CITY DEVELOPMENT DELEGATED COMMITTEE AGENDA

**PLANNING APPLICATION TP113/2025(1) - 18 BIRDWOOD STREET,
MARIBYRNONG**

Director: Mike McIntosh
Director Planning and Environment

Middle Footscray Activity Centre – proposed train and tram activity centre boundary

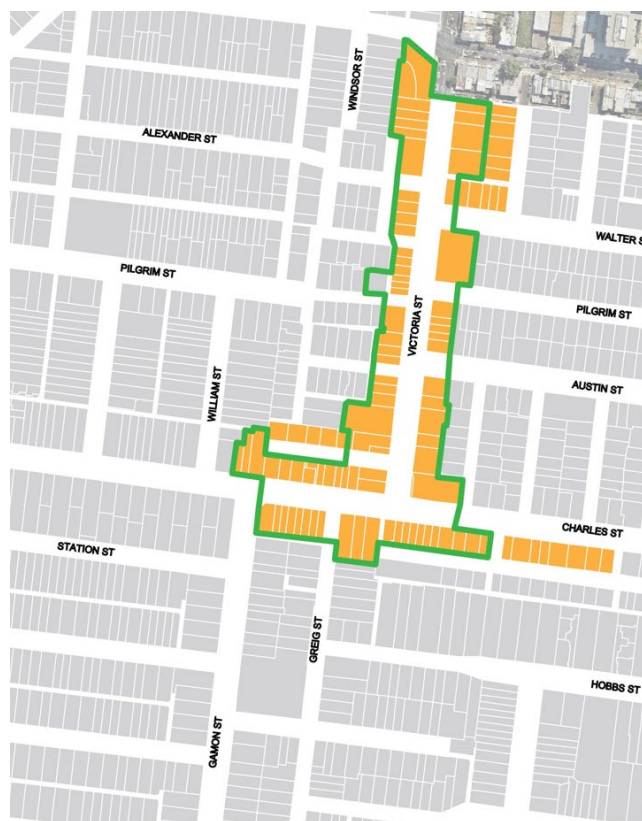
4.11 Having reviewed the Draft Maps, Council considers that they do not address the feedback received as part of Phase 1 engagement or the statement of advice from the Tottenham Community Reference Group.

Figure 5: Comparison of West Footscray Neighbourhood Plan (2022) Activity Centre boundary to the proposed train and tram activity centre boundary

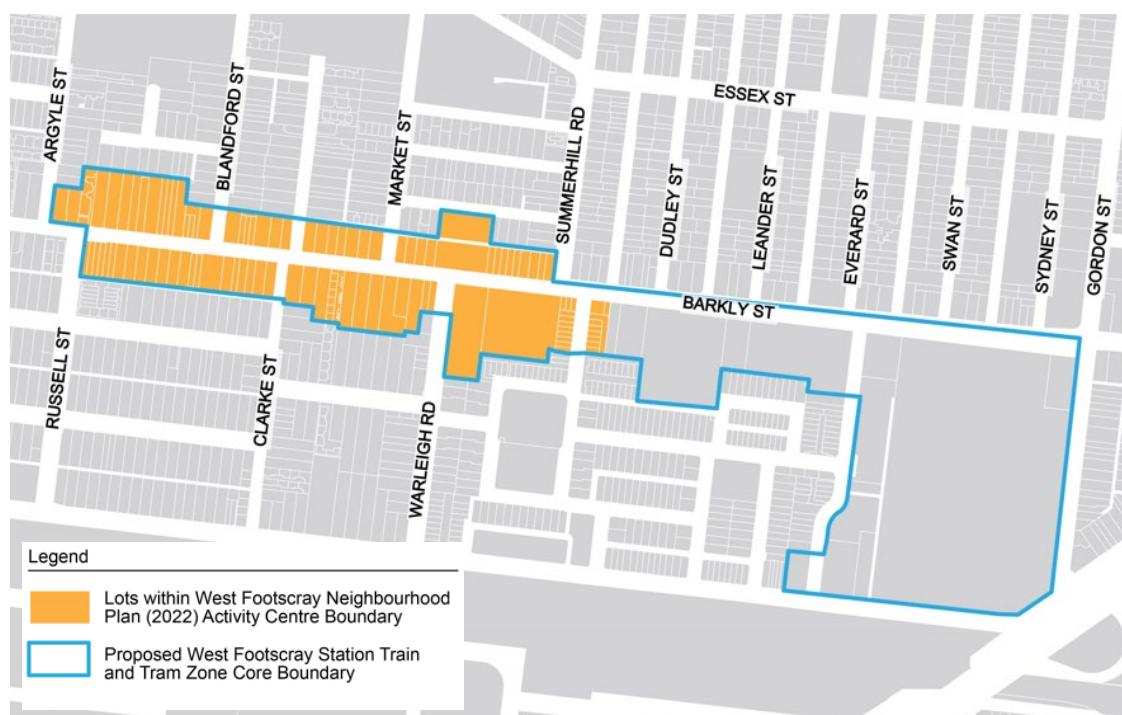
- 4.21 This strategically justified work is not reflected in the proposed West Footscray train and tram activity centre boundary, which is significantly larger than the Neighbourhood Activity Centre boundary identified in the West Footscray Neighbourhood Plan, see Figure 5 below.

- 4.22 Accordingly Council considers that the following sites should be removed from the DTP proposed West Footscray train and tram activity centre boundary:

Figure 7: Existing heights allowed, as set out in West Footscray Neighbourhood Plan, page 22

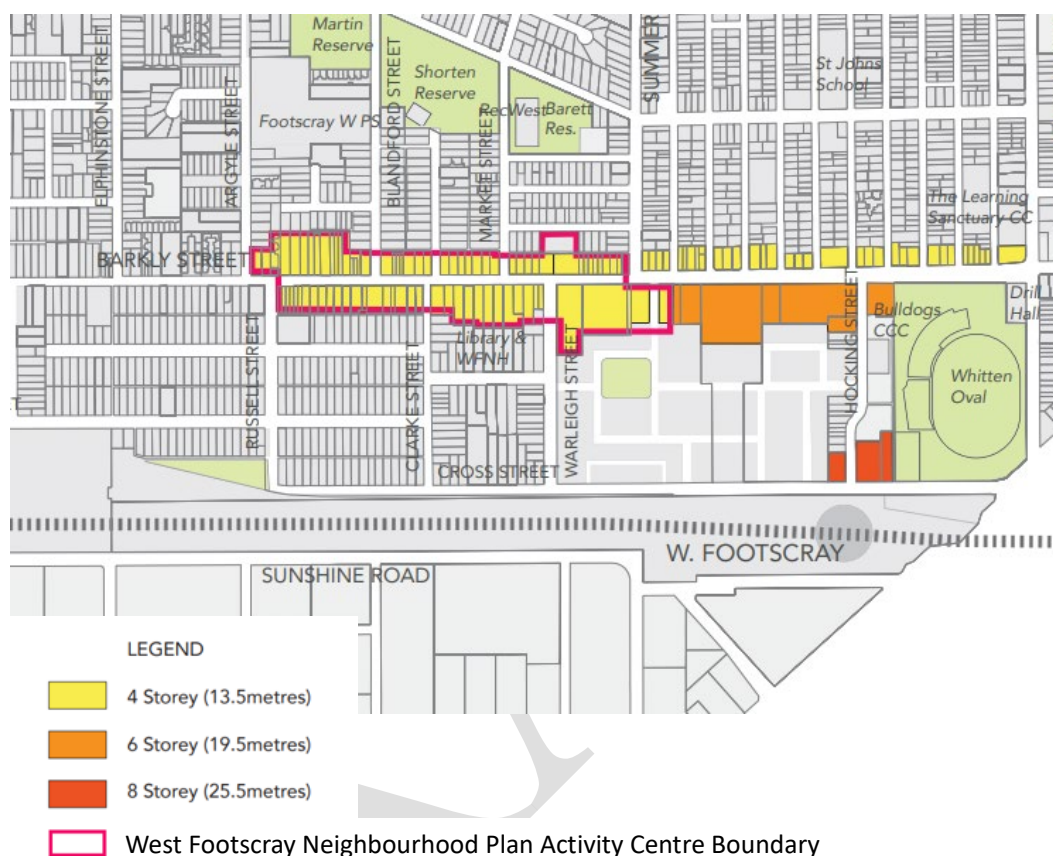
- 4.26 These controls reflect the built form analysis undertaken as part of the preparation of the West Footscray Neighbourhood Plan, that gave consideration to the existing and emerging built form character, lot configuration and interfaces with neighbouring properties:

- 4.27 Allowing heights up to 12 storeys, without any form of master planning, will impact Barkly Street, sensitive residential uses and open spaces through overshadowing. This and the overwhelming nature of the proposed built form is demonstrated by Figure 8 below.
- 4.28 Council also notes that the proposed 12 storey height exceeds the core height range as specified in DTP's Housing Growth Index Assessment Process. West Footscray Station was identified as Housing Growth Index 2 which has a core height range of primarily 6-8 storeys.

Figure 9: Comparison of existing Activity Centre boundary to the proposed train and tram activity centre boundary

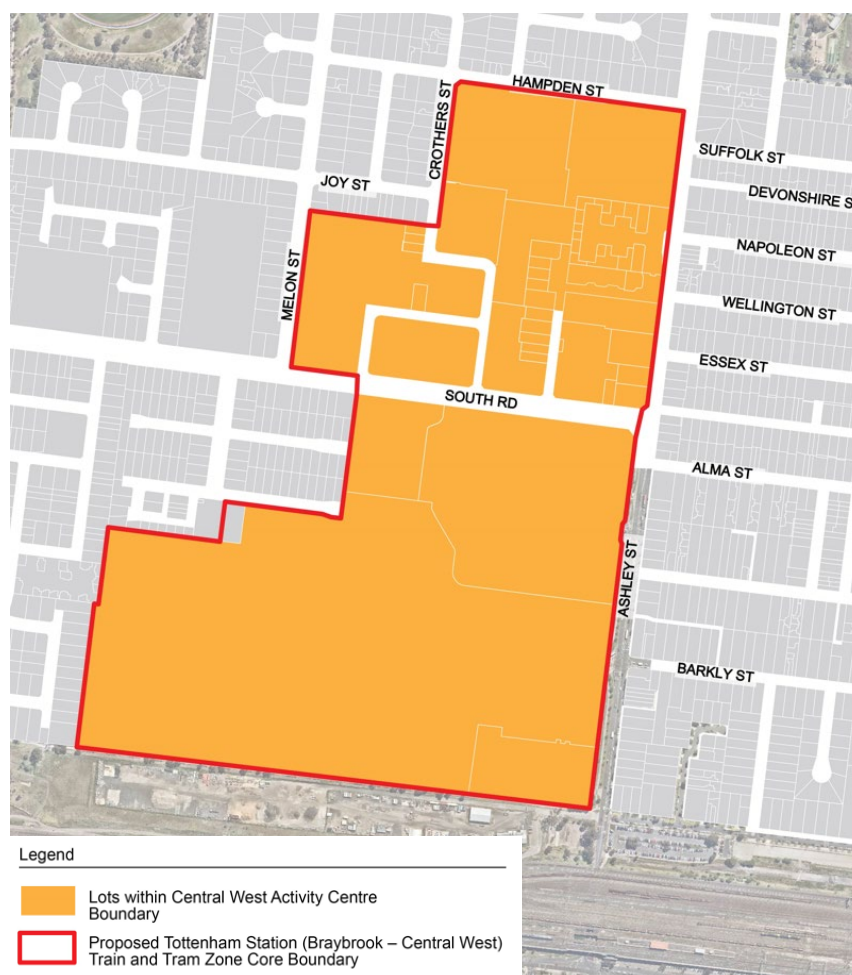
- 4.29 Council supports the proposed train and tram activity centre boundary because it is consistent with the existing activity centre boundary, see Figure 9 below.

Figure 12: Inner catchment areas proposed

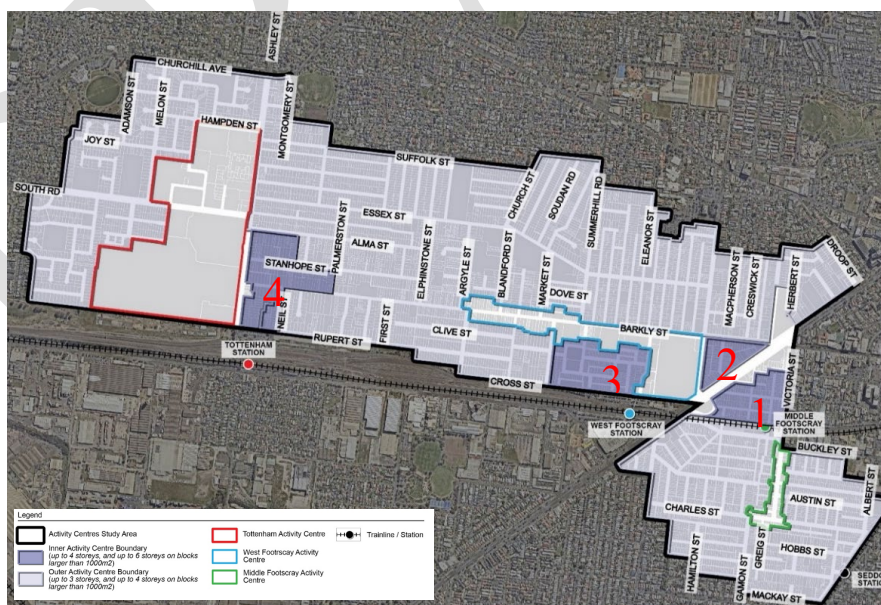
- 4.35 Inner catchment areas have been identified to accommodate increased growth through the application of the Housing Choice and Transport Zone (**HCTZ**). This will allow for increased densities from up to 4 storeys and up to 6 storeys on sites larger than 1,000sqm.
- 4.36 Four inner catchment areas have been identified in the study area. Council officers have numbered these for ease of reference, as shown in Figure 12 below.
- 4.37 Council supports the designation of Area 4 as an inner catchment area. However, for the reasons below, Council submits that areas 1, 2 and 3 should be removed from the inner catchment areas and instead, be designated as outer catchment areas.

Figure 13: Inner catchment area 1 - constraints analysis

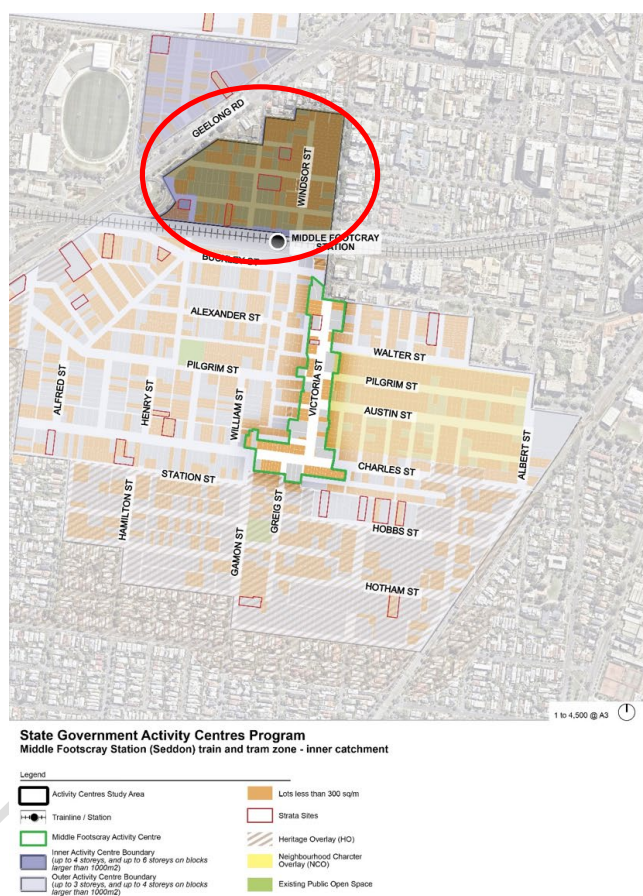
- 4.38 This inner catchment area, bound by Victoria Street, Geelong Road and the railway line, forms the Buckingham Street Neighbourhood Character Precinct. This area is characterised by a diverse range of housing, however low scale timber dwellings is the prevailing form. Please see figure 13 for the constraints analysis on this inner catchment area.

- 4.39 The Neighbourhood Character Overlay (**NCO**) applies to the land in this area and seeks to protect the existing character. Current planning controls, to align with the intent of the NCO, mean new buildings are sited in accordance with the predominant pattern of setbacks in the street and important features of the precinct such as low front fences and views to small front gardens are retained.
- 4.40 The majority of lots within this area are less than 300sqm, meaning their development potential without significant lot consolidation is limited. The proposed new controls are

Figure 16: Proposed outer catchment boundary

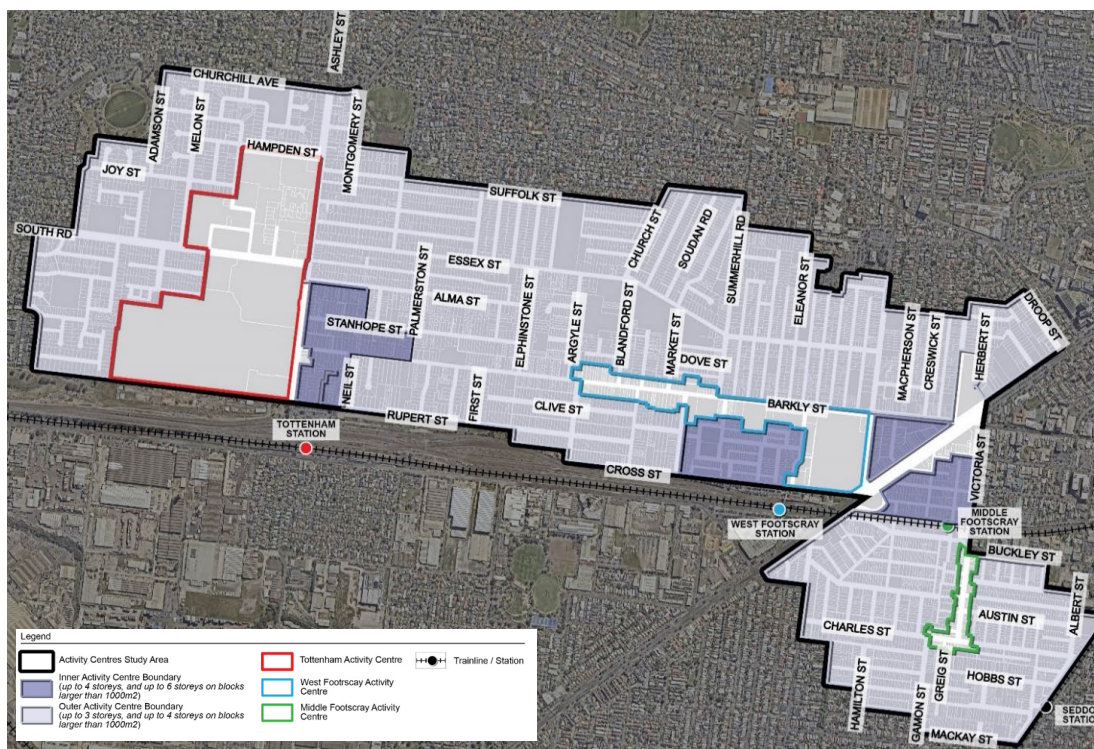
- 4.51 The outer catchment has been applied to a large area with the approximate boundary of Droop Street to the east, Suffolk Street to the north and the railway line to the south. Figure 16 reflects the extent of the proposed outer catchment boundary.

- 4.52 Large parts of the area identified as outer catchment, especially in the north, are a significant distance and physically disconnected from the train stations and core area of the activity centre. Council's walkability analysis has found that large parts of this proposed catchment is not within a 10 minute walking distance from either a train station or activity centre: Figure 17 illustrates the areas that are located within a 10minute walking catchment of a train station and/or activity centre. Accordingly, the outer catchment area should be reduced to reflect a true walking catchment. Noting that this is a stated aim of applying the outer catchments, it is difficult to understand why the boundaries have been extended so far beyond these areas.

Figure 18 Existing Open Space gaps (areas in white/grey) within Activity Centre boundaries

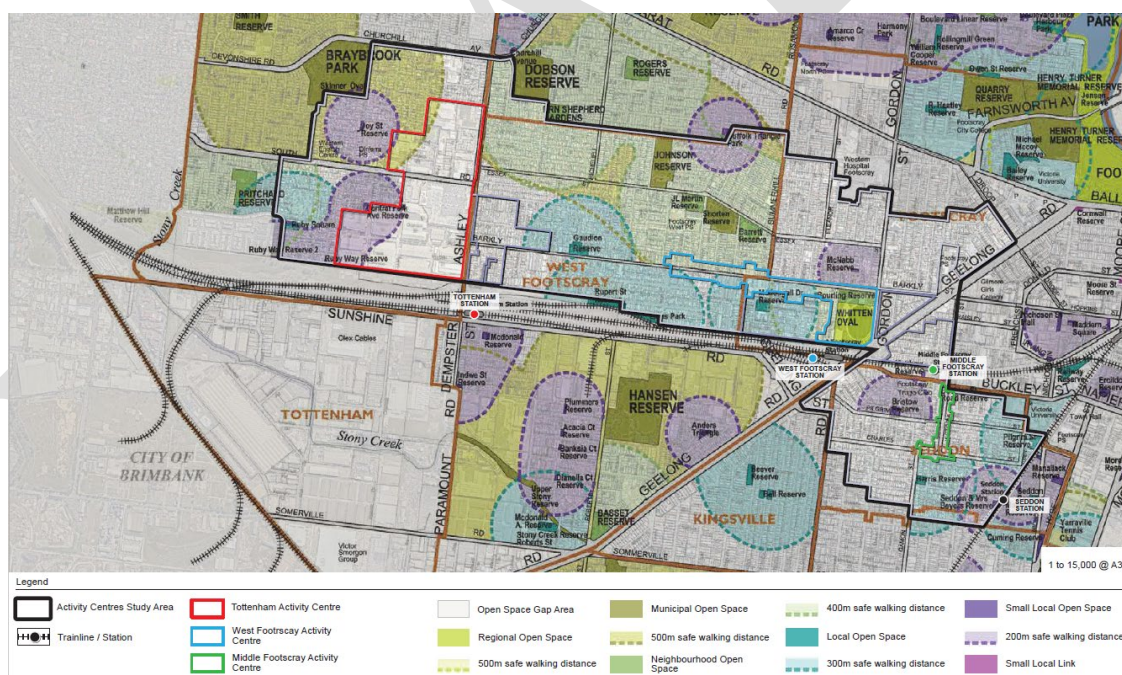
- 8.4 The City of Maribyrnong Open Space Strategy 2014 (**Open Space Strategy**) and Open Space Strategy 5 year Review Addendum Report June 2020 (**Open Space Strategy Addendum**) identify a number of gaps in the existing open space network, as shown in Figure 18 below. This includes areas within the Activity Centre Program catchment area.

- 8.5 Given the existing shortfall and the increased density and population proposed, the need for new open spaces to be identified and delivered, in partnership with the State
